# TEXAS COMMISSION ON ENVIRONMENTAL QUALITY

## NOTICE OF AN APPLICATION FOR A WATER USE PERMIT

APPLICATION NO. 13740

Miramont Country Club Properties, L.P. requests authorization to maintain eight reservoirs on unnamed tributaries of Hudson Creek, Hudson Creek, and an unnamed tributary of Carters Creek, Brazos River Basin, impounding 108.9 acre-feet of water for recreational purposes in Brazos County. The applicant also seeks authorization to use the bed and banks of unnamed tributaries of Hudson Creek, Hudson Creek, and an unnamed tributary of Carters Creek to convey 736 acre-feet of groundwater for storage in the reservoirs and for subsequent diversion and use for agricultural purposes in Brazos County. More information on the application and how to participate in the permitting process is given below.

# Worksheet 4.1

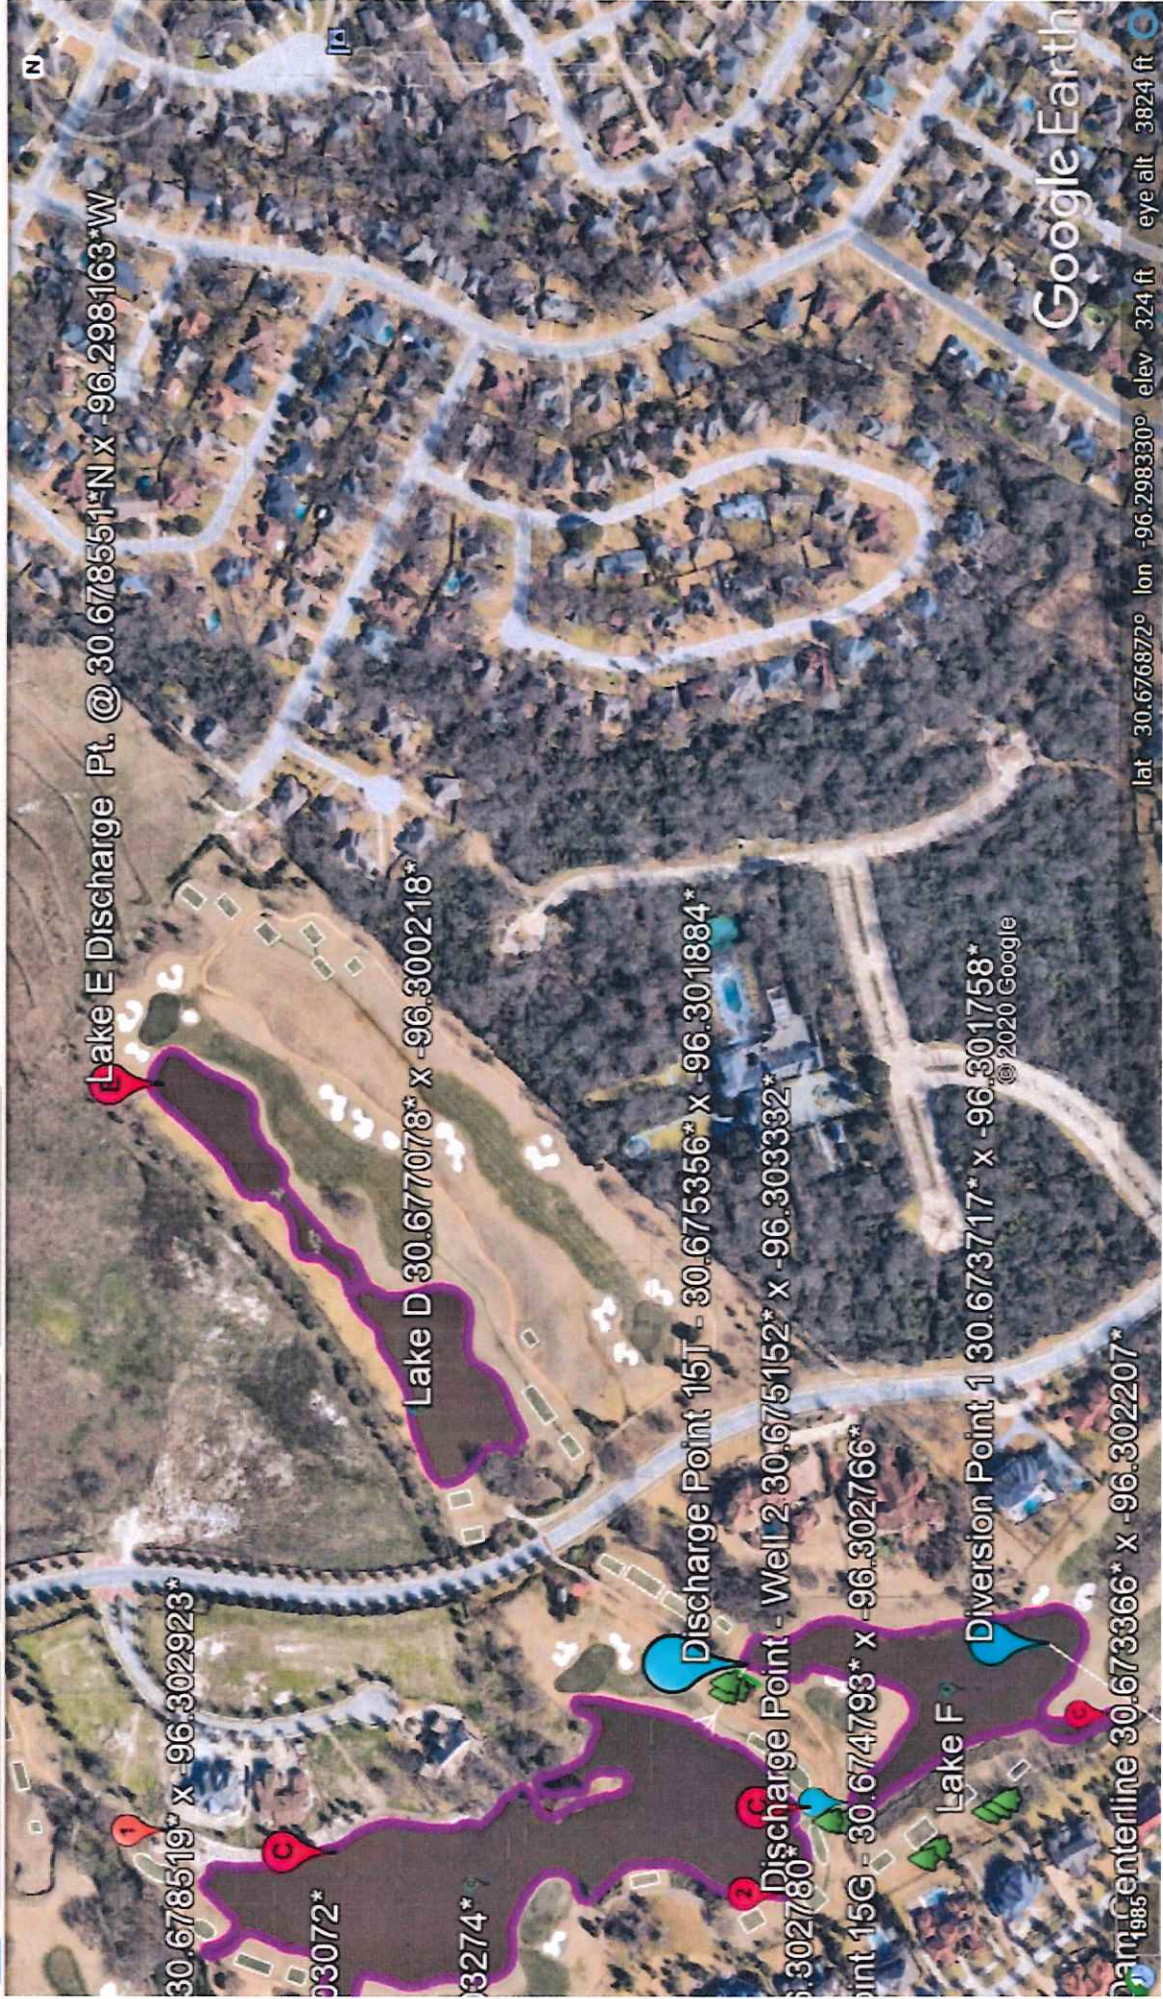
- 1. Provide a completed Worksheet 4.1 for the discharge point into Lake E. Staff notes that the Worksheet 4.1 provided in the response was for Lake F.

**Response:** Please see attached Worksheet 4.1. The Discharge Point is at the upper end of Lake E. This point is an open-ended 14” PVC pipe that originates in our Pump Station and is simply a water recirculation feature. The pump and pipe provide flow of approximately 2000gpm that fills Lake E to the point of overflow, cascades over a series of rock waterfalls into Lake D, over another rock waterfall and returns to Lake F completing the loop. We program this Water Feature Pump to run, on average, eleven hours daily, six days per week, and fifty weeks per year which accounts for the 1,215.28 AcFt from this discharge point. Lake E, like all other reservoirs on property have numerous sprinklers along the perimeters that can aid in capacity maintenance.

# Lake A Perimeter Sprinkler Locations

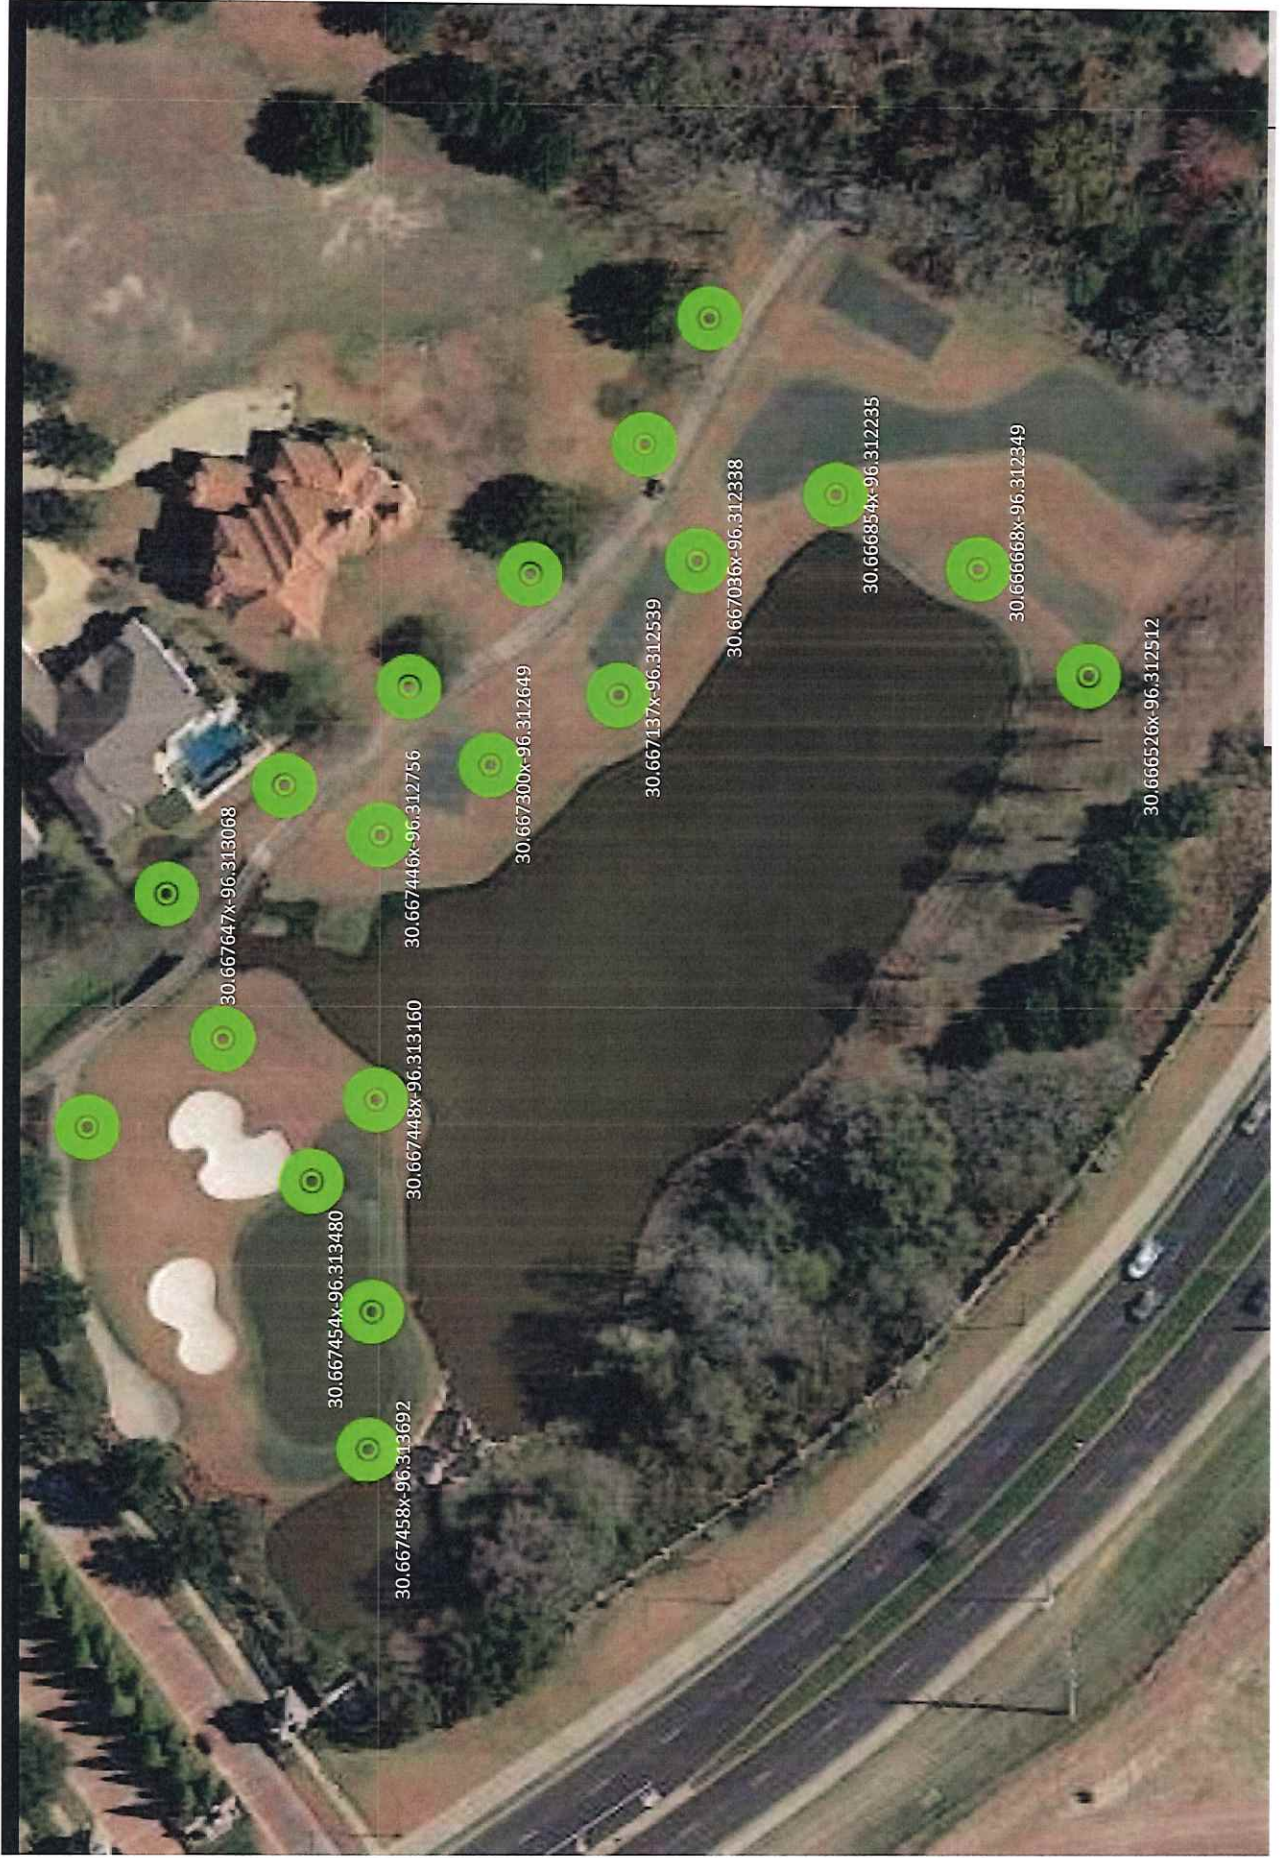
1. Provide a completed Worksheet 4.1 for the discharge point into Lake E. Staff notes that the Worksheet 4.1 provided in the response was for Lake F.
2. Confirm that groundwater will be discharged at the perimeters of Lake A, G, and 21 as represented in the table below:

Response: Yes, Confirmed. Groundwater is and can be discharged at the perimeters of each lake through the permanent golf sprinklers, but at various points around each lake, not specifically at the coordinates listed in the table. Please see attached maps for each reservoir with sprinkler locations noted.
